UNITED STATES PATENT AND TRADEMARK OFFICE

APPLICATION NO.	FILING DATE	FIRST NAMED INVENTOR	ATTORNEY DOCKET NO.	CONFIRMATION NO.
10/811,055	03/26/2004	John B. Cline	1626-309	7598

Office Action Summary

DETAILED ACTION

Fig. 2

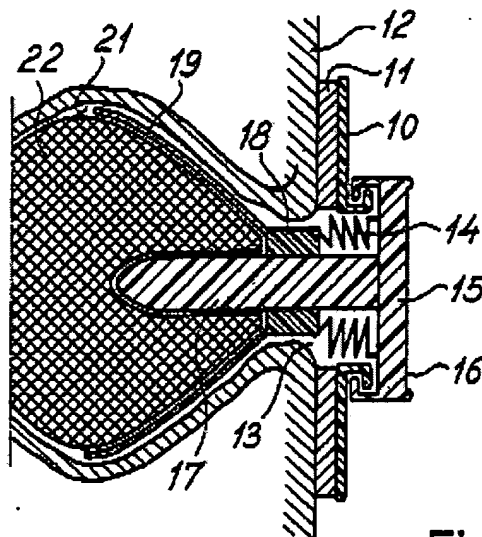
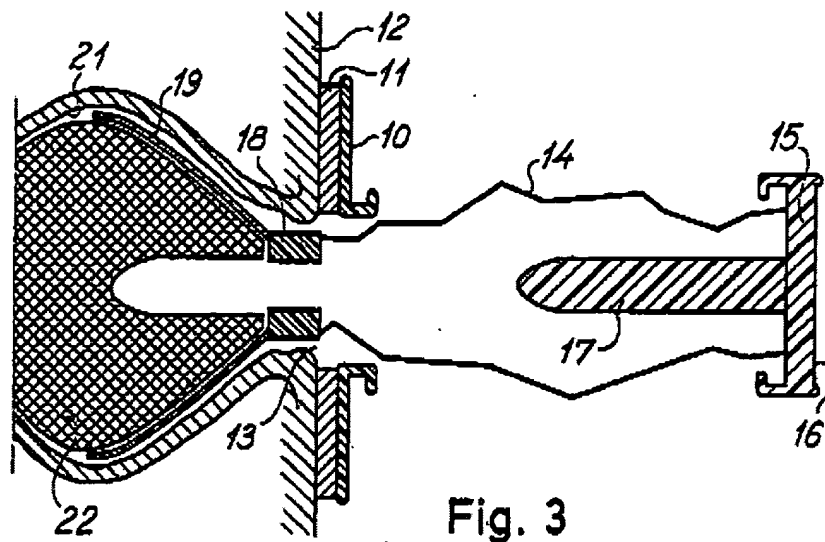
Regarding claim 35, Bar-Shalom teaches an ostomy device capable of sealing a stoma said device comprising recess defining means (16); means (10, 11) for securing said recess defining means (16) to the body (12) proximate the stoma (13); and stoma covering means (10, 11, 14), situated externally to the body (12), over the stoma, within said recess defining means (16), said recess defining means (16) defining, with said stoma covering means (10, 11, 14), a

recess (area under stoma defining means (16)) capable of being pressurized to press said stoma covering means (10, 11, 14) against the stoma (13)(see figure 2, infra).

Regarding claim 36, Bar-Shalom teaches the stoma covering means (10, 11, 14) comprises a flexible member (14).

Regarding claim 37, Bar-Shalom teaches a stoma covering means (10, 11, 14) having an upper edge fixed to the interior of said recess-defining means (16)(see figure 2).

Regarding claim 38, Bar-Shalom teaches a means (16, 19) for pressurizing the recess.

Regarding claim 41, Bar-Shalom teaches a that the recess defining means is a pump means (it can be moved back and forth in a reciprocating manner, it can be pressed against receptacle (14) to increase the internal pressure thereof.

Regarding claims 44 and 46, Bar-Shalom teaches a means (15) for applying and/or limiting external pressure on the stoma (it can be pressed into place by hand, and pressure placed thereupon can be limited by hand.

Regarding claim 49, Bar-Shalom teaches a second recess, the small gap between recess defining means (16) and stoma covering means (10, 11, 16). Bar-Shalom also teaches a filter means (page 8, lines 18-21).

Regarding claims 50 and 51, Bar-Shalom teaches removable means (10, 11) for engaging and adhering the recess defining means (16) to tissue (12) surrounding a stoma (13).

Regarding claims 52-56, Bar-Shalom teaches a collapsible concertina-like waste collection means (14) comprising a pouch (see figure 2) having its upper end connected to a securing means (10, 11, 16).
